IFB No. 16-62 Washington Academy Renovations - REBID

RE: ADDENDUM NO. 2

Subject: **CHANGES to the BIDDING DOCUMENTS**

Project: **RENOVATIONS TO
WASHINGTON ACADEMY - REBID
ROCKFORD PUBLIC SCHOOLS
ROCKFORD, ILLINOIS**

BOILER ROOM - LPS PIPING NEW WORK PLAN

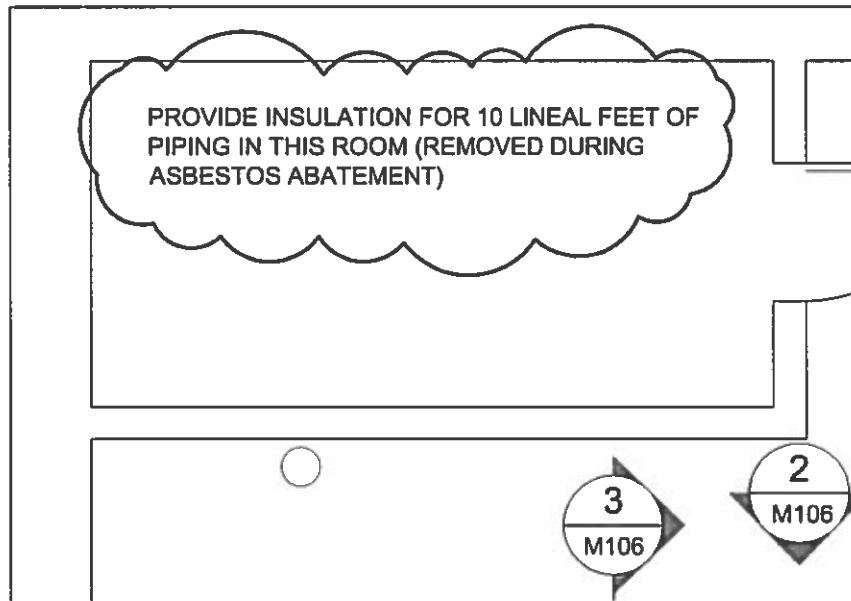
- 2.1. See attached addendum drawing ADM2.1 showing the additional piping insulation required due to asbestos abatement.
